005 -24 MV
n°

Technical Bulletin

Subject: **MCU cod. SPMV8000D1269**

Product: **LXP 950 Orioli \ Enduro Veloce**

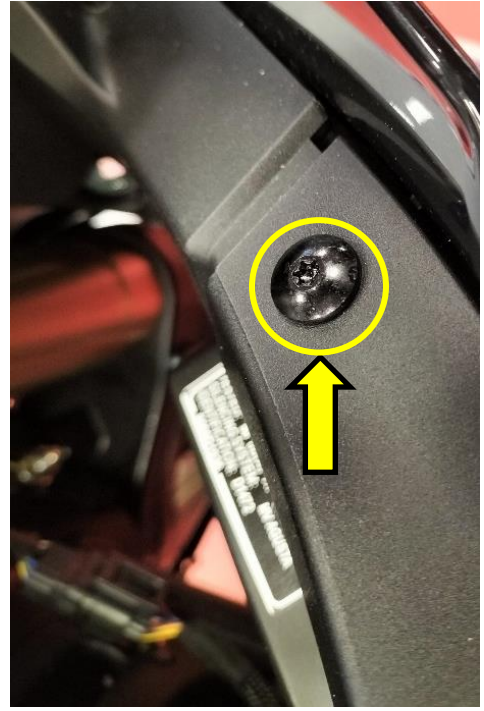
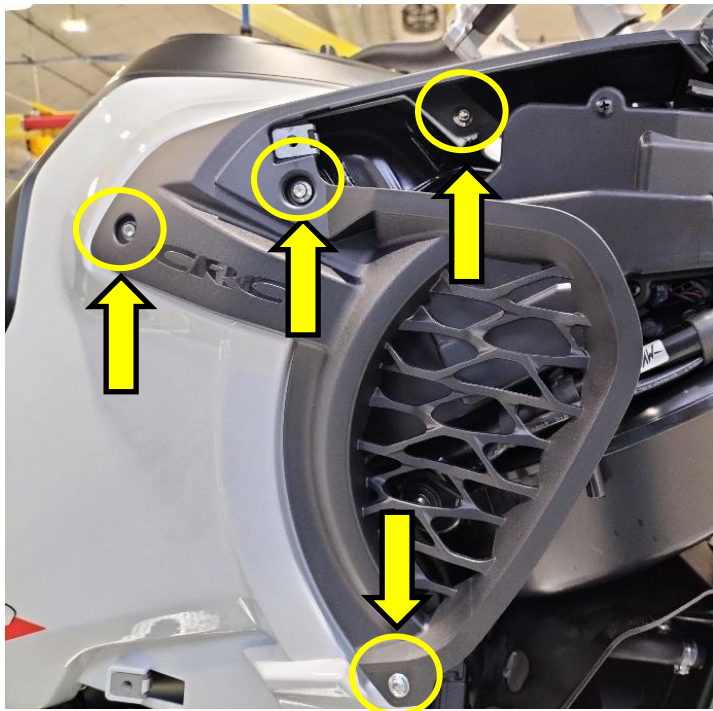
- Place the motorcycle on the central stand.
- Remove the right-side pannier operating on the screws indicated in the pictures and disconnecting the right turn signal:

NOTE: it is possible to extract the side panel even if the vehicle is equipped with the bullbar, by slightly flexing the front part of the fairing in order to extract the front fixing point of the same passing it between the bike and the bullbar. Be careful not to damage the paint against the bullbar.

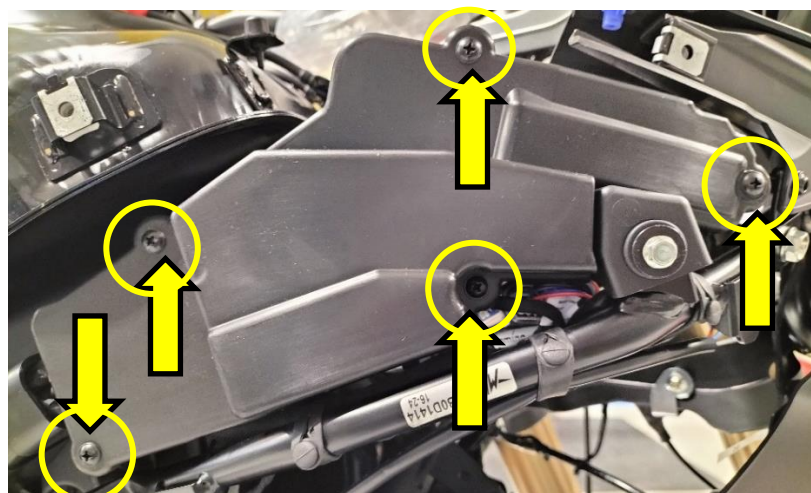
- Remove the air extractor by acting on the screws indicated in the picture:

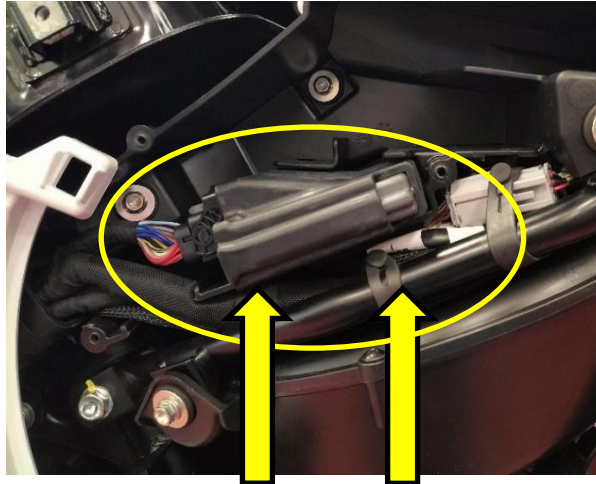
- Remove the control unit support cover using an adequate Phillips screwdriver:
